RE: JMC Project 20044
 4 Tripp Lane Zoning Compliance
 4 Tripp Lane
 Town of North Castle, New York

Response to Kellard Sessions and Town of North Castle Planning Department Comments

This letter has been prepared to address comments and correspondence received from Kellard Sessions, dated September 22, 2023, the Town’s Planning Department staff report dated September 19, 2023, and HydroEnvironmental Solutions, Inc., dated September 22, 2023.

CUT AND FILL PLAN
PEREIRA RESIDENCE
4 TRIPP LANE
NORTH CASTLE, NY

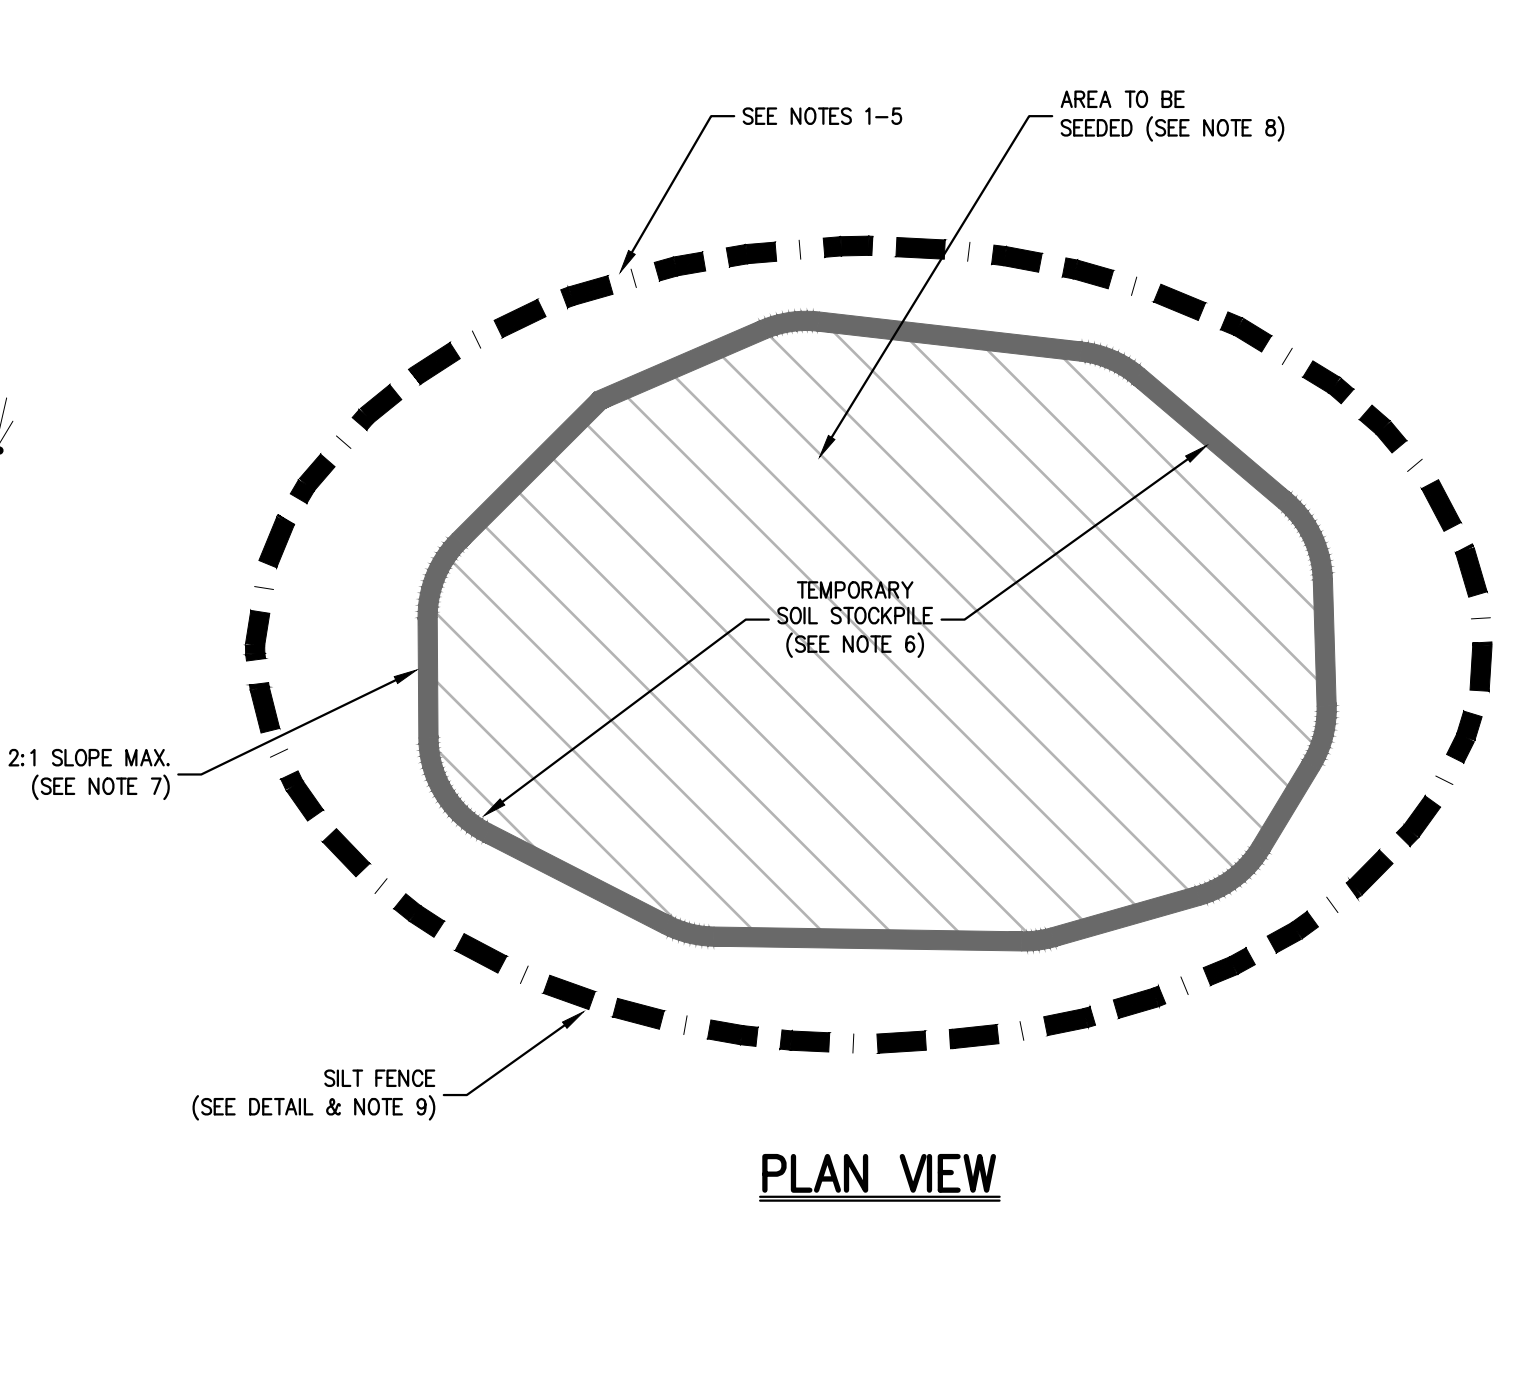
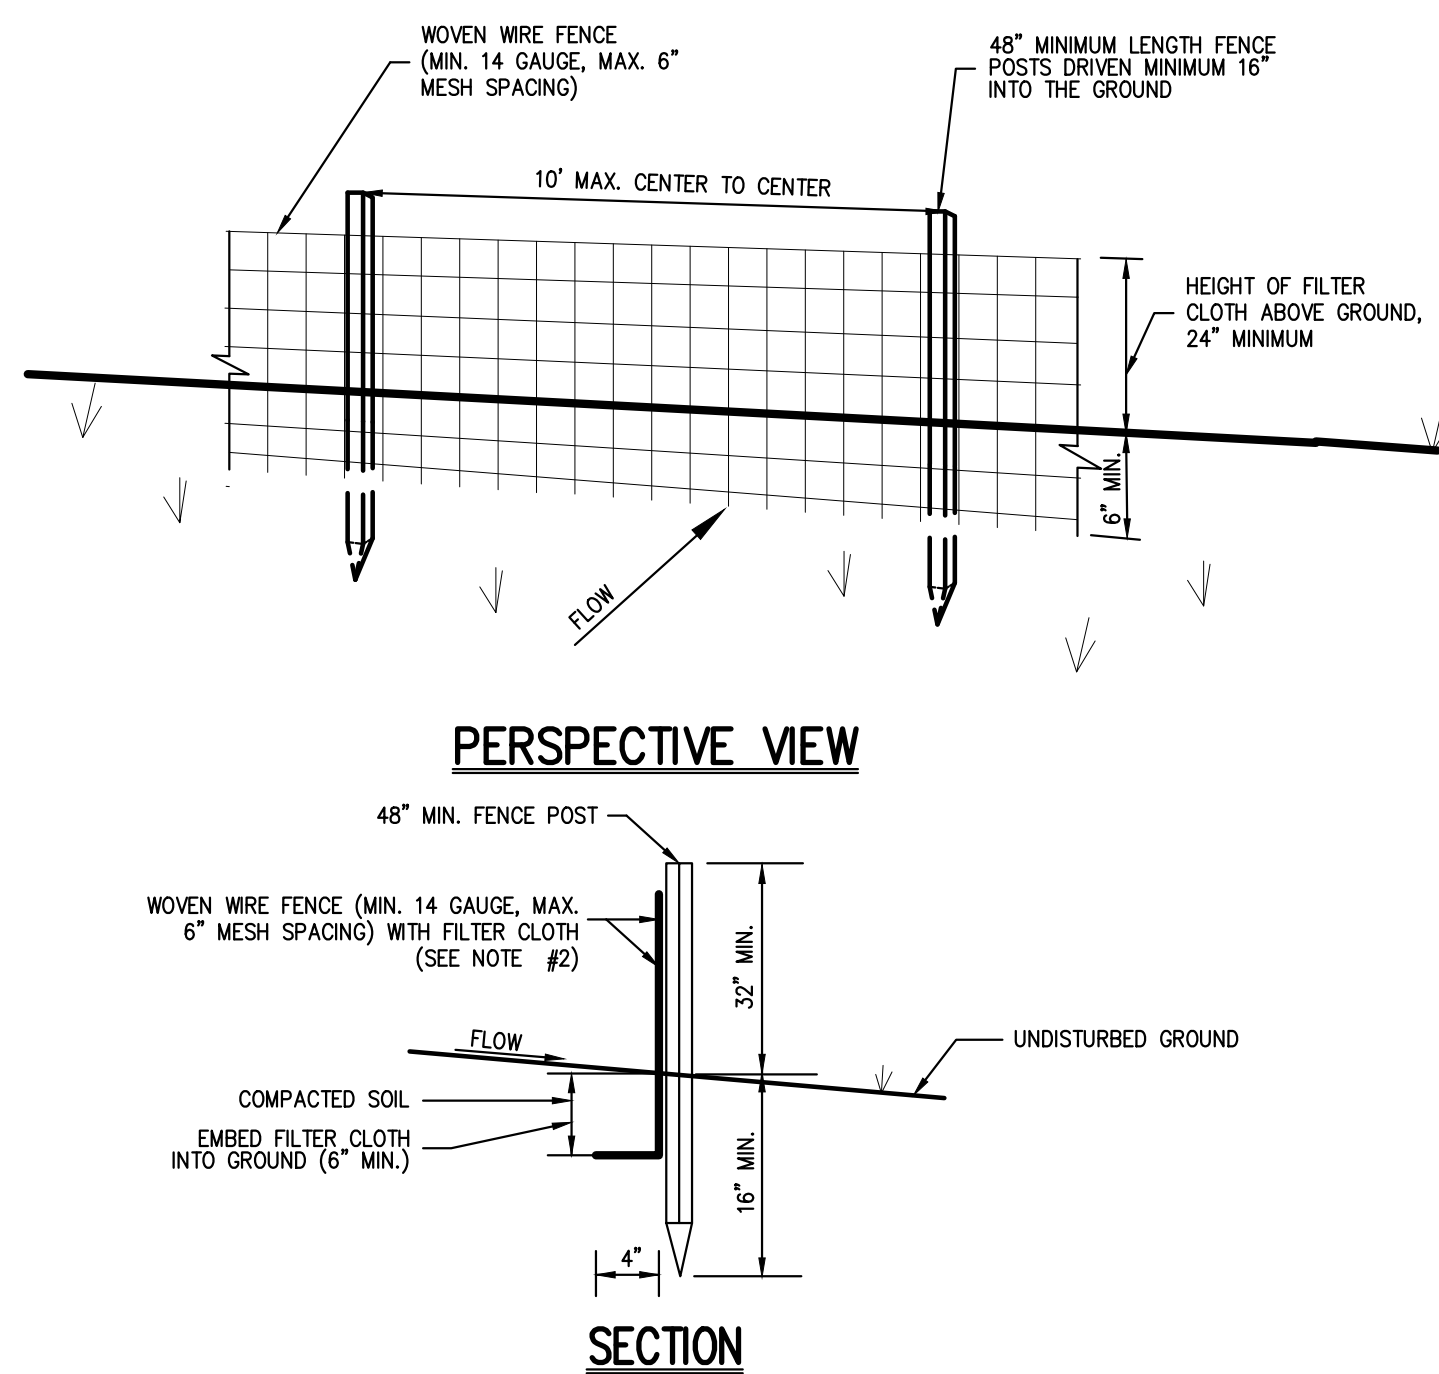
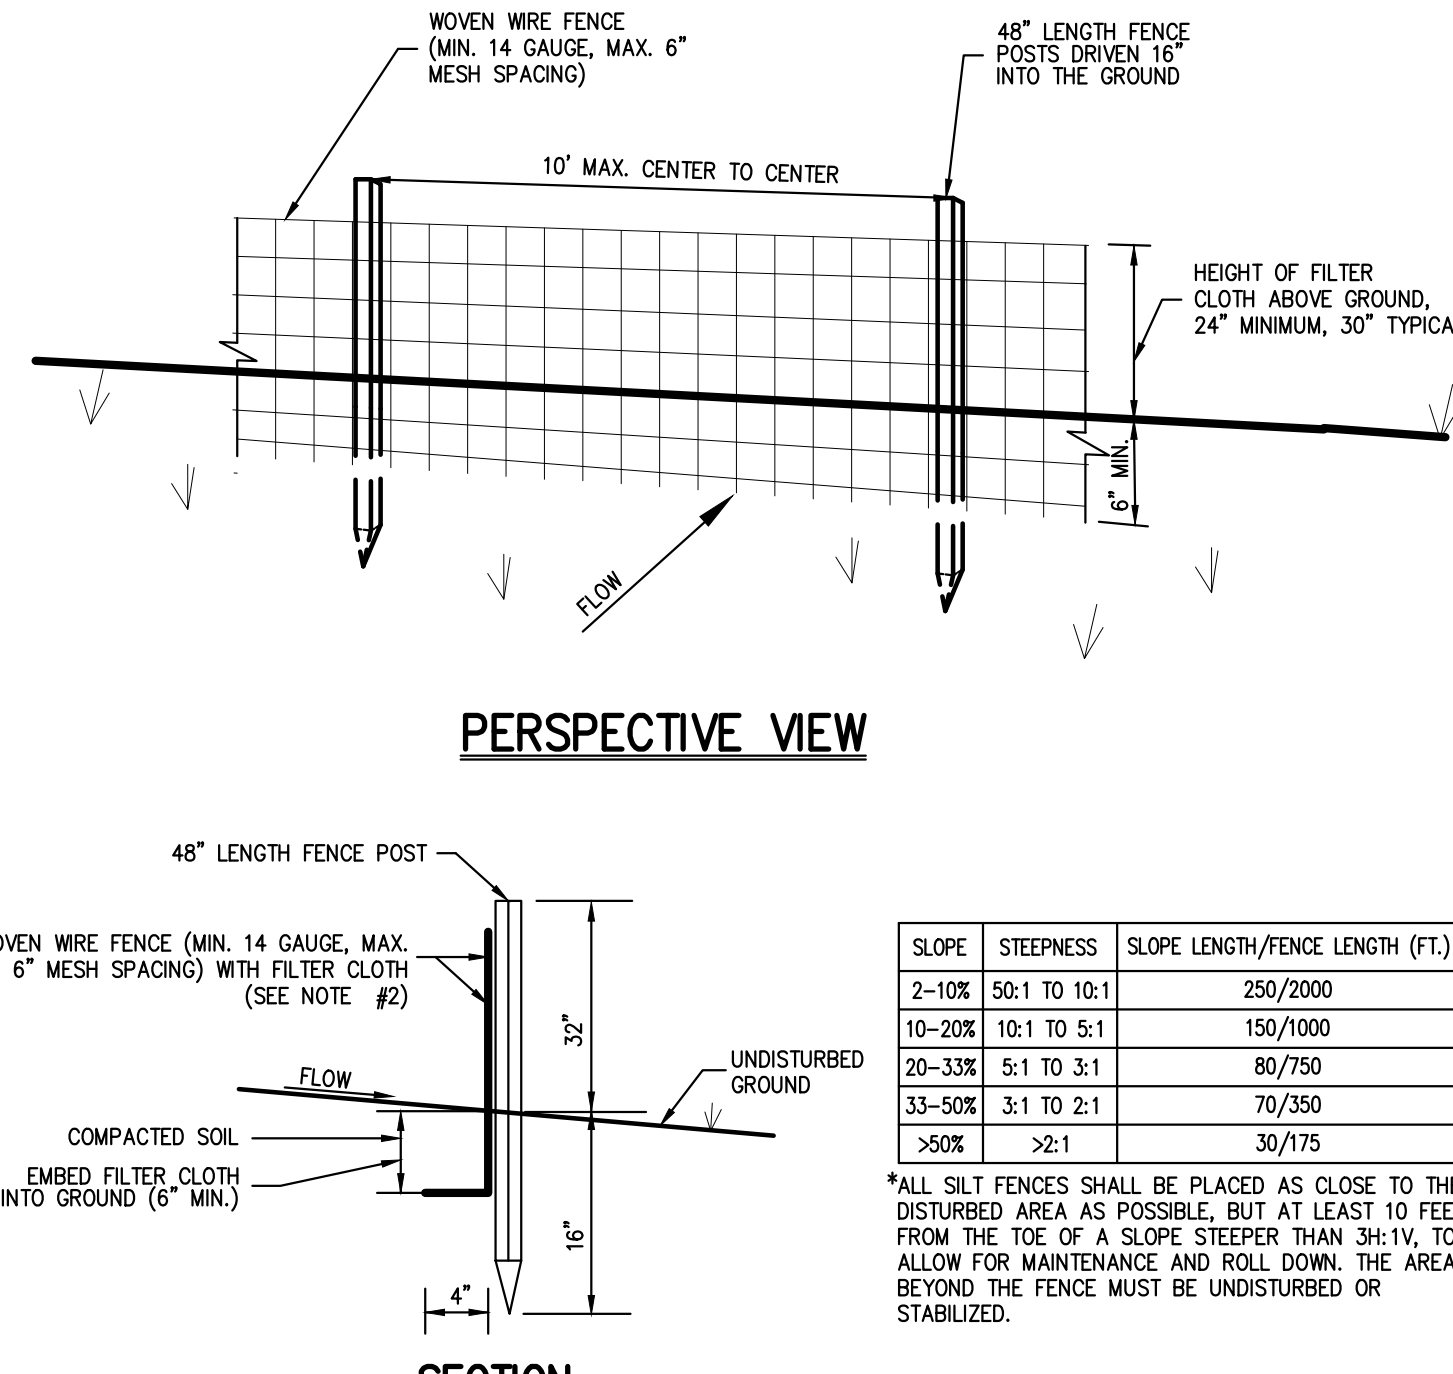
As previously requested, the cut and fill plan should overlay the surveyed topography onto the pre-developed GIS topography to illustrate the cut and fill volumes established between pre-existing conditions and existing conditions. The fill sampling and testing was reviewed by the Town's Environmental Consultant. It was agreed that the fill remain in place with a 24-inch soil cap and a demarcation layer (orange fence or geotextile membrane) placed above the existing fill section. The soil cap shall include a minimum six (6) inch layer of topsoil. This has been noted and detailed on the plan. However, the applicant shall prepare a proposed grading plan to illustrate how the add fill will be accommodated on the site and what, if any, added modifications to walls, walks, drives, etc., may be needed as a result. The applicant must also prepare an erosion and sediment control plan to illustrate and detail temporary access to the site and protection of the septic field for the import of clean fill, as well as all temporary sediment and erosion control measures that will be required.

The applicant has revised the scope of the project to propose the removal of approximately 704 cubic yards of imported fill, which appears after extensive testing on the site, concentrated in an area located along the western property boundary. The applicant has stated, during a meeting on August 6, 2023, held at Town Hall, between the Applicant, The Planning Department, and our office, that test pits have revealed that the imported fill did not extend to the rest of the site as originally assumed. We defer to the Board on the acceptance and limits of the new imported fill removals.

The client awaits a final decision on the matter from the Planning Board.

CHAIN LINK FENCE
(GALVANIZED) - ALREADY INSTALLED AND WAS MEASURED IN THE FIELD

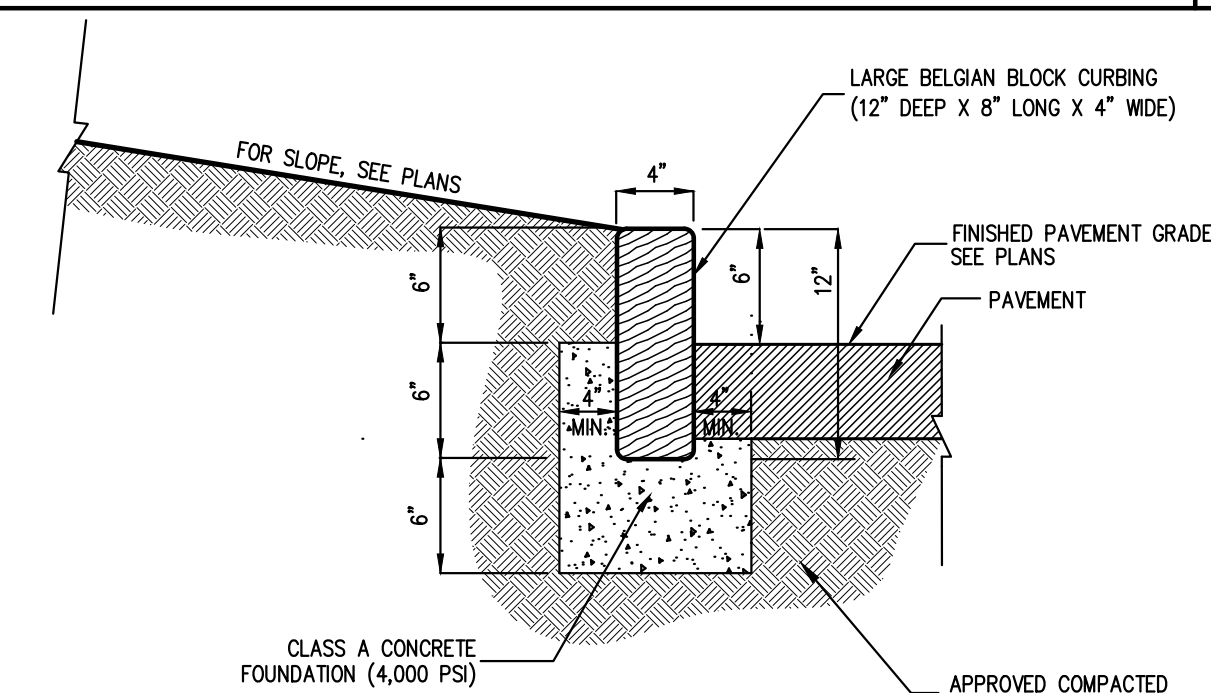
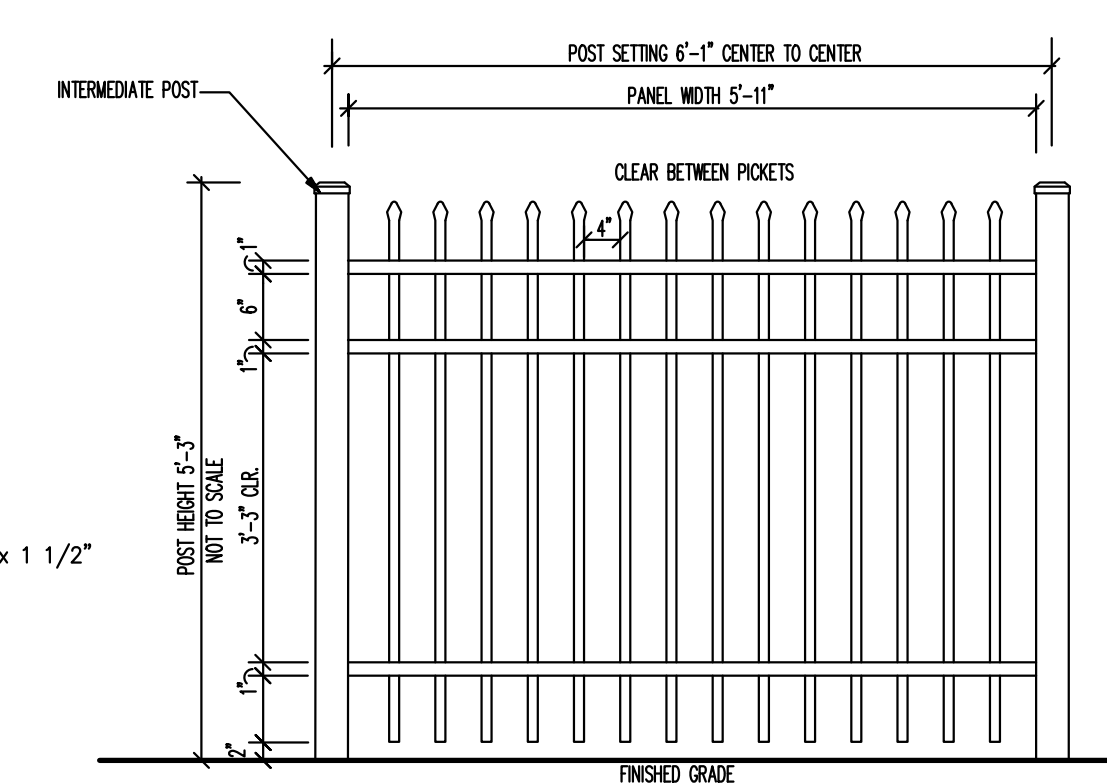
As previously noted, the plans illustrate existing six (6) foot high black vinyl coated chain link fence

and aluminum fence and a proposed four (4) foot high black vinyl coated chain link pool fence; however, fence details No. 10 and 11 are for proposed fences of 5 feet 3 inches and 5 feet 2 inches in height. Please coordinate between the plan and details.

The plans have been updated and are now coordinated to depict the fence heights correctly.
